MIL-M-83329B(USAF)
Amendment 3
24 Apr 80

MILITARY SPECIFICATION

MODIFICATION KIT, LIQUID FUEL
FILTER-SEPARATOR KMU-417/F

This amendment forms a part of Military Specification
MIL-M-83329B(USAF) dated 6 February 1973

FIGURE 3. Coalescer-Separator Installation

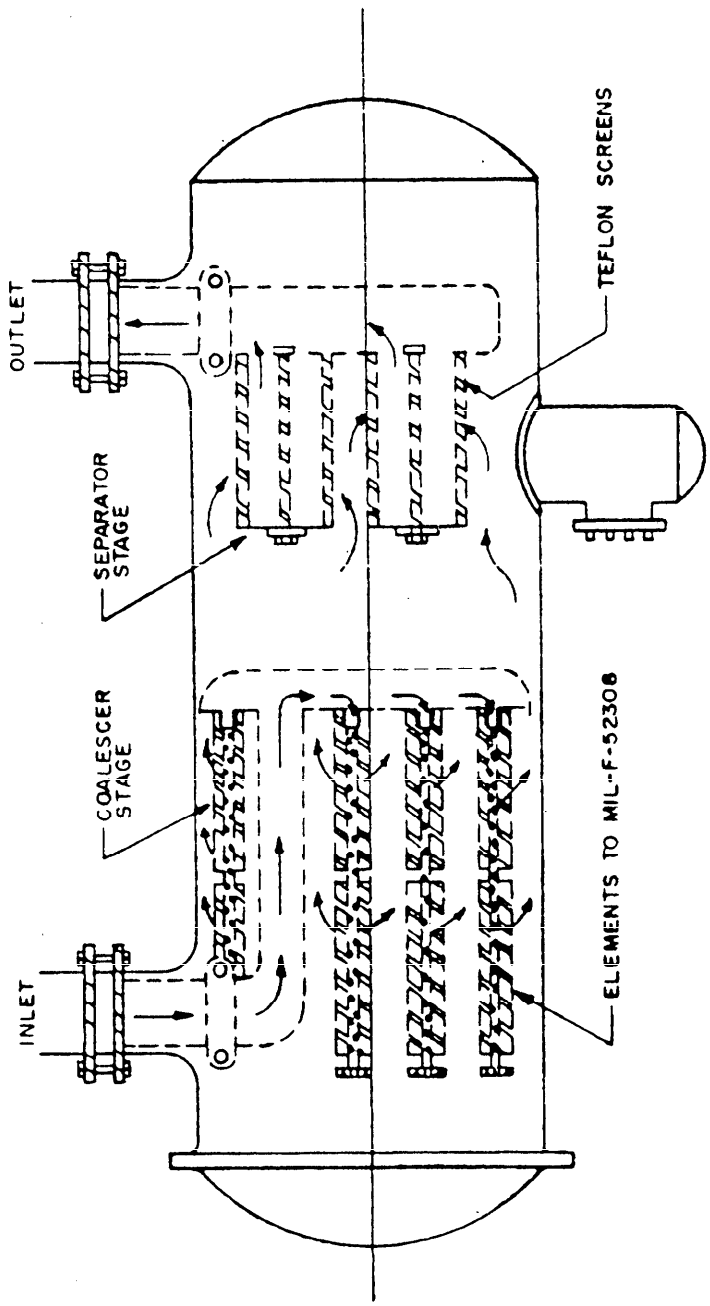
Page 2, paragraph 3.3.1.1, line 8: Add "See figure 3."

Add figure 3. Figure 3 forms page 3 of this amendment.

Page 5, paragraph 3.3.1.4: Delete and substitute:

"3.3.1.4 Filter (coalescer) element manifold assembly. The filter element manifold assembly shall be designed to accept 30 elements conforming to MIL-F-52308. It shall be provided with either 15 or 30 element mounting tubes depending upon whether the elements will be single or double stacked. The mounting tubes shall be welded or permanently sealed to the inlet manifold. The design shall be self-contained so it can be installed, assembled, and connected by removal of the front closure plate. Internal pipe connections shall be aluminum alloy and shall conform to MIL-C-10387, or equal. Manifold support braces shall be provided as necessary to secure the assembly during operation. Typical design requirements are shown on figure 3."
